COLLECTION OF THE CTL DECISIONS
DECISION SHEET

Standard:	**Sub clause:**	**Sheet No.**
IEC60065 6ed.	13.2	**525**
Subject	**Key words:**	**Decision taken at the 40th meeting 2003**
Applied force for internal parts	force for internal parts

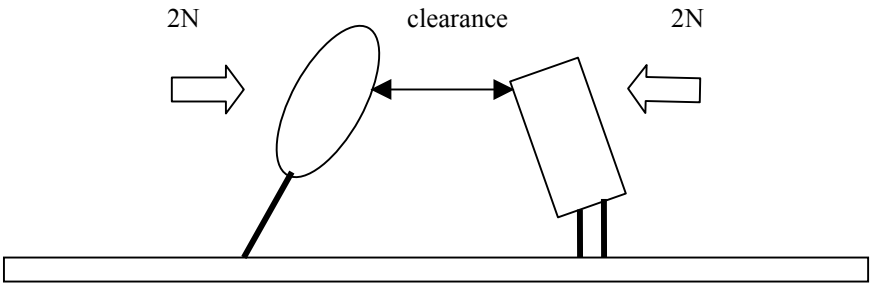
In clause 13.2, it is specified that 2N for internal parts and 30N for the outside are applied simultaneously while taking measurement of clearance. However, it is not specified that forces are applied to internal parts while taking measurements between two internal parts, ex. primary circuit component and secondary circuit component.
Which is the appropriate method to measure clearance between two internal parts ?

a) 2N forces are applied to the both parts simultaneously.

b) First, a 2N force is applied to one part and removed. And then a 2N is applied to the other one.

First, a 2N force is applied to one part and removed. Then a 2N force is applied to the other part.

Explanatory Notes:

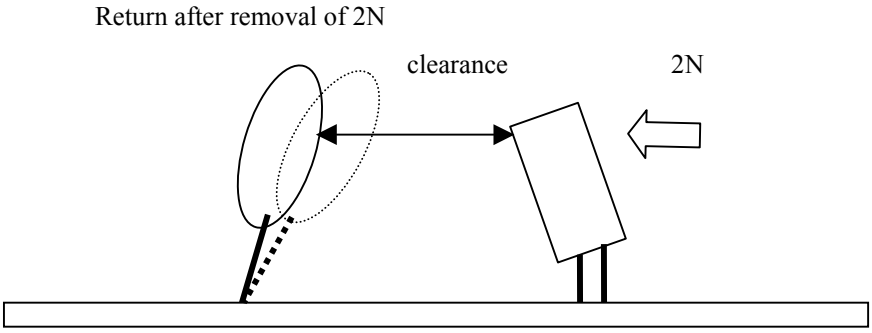
a)

b)
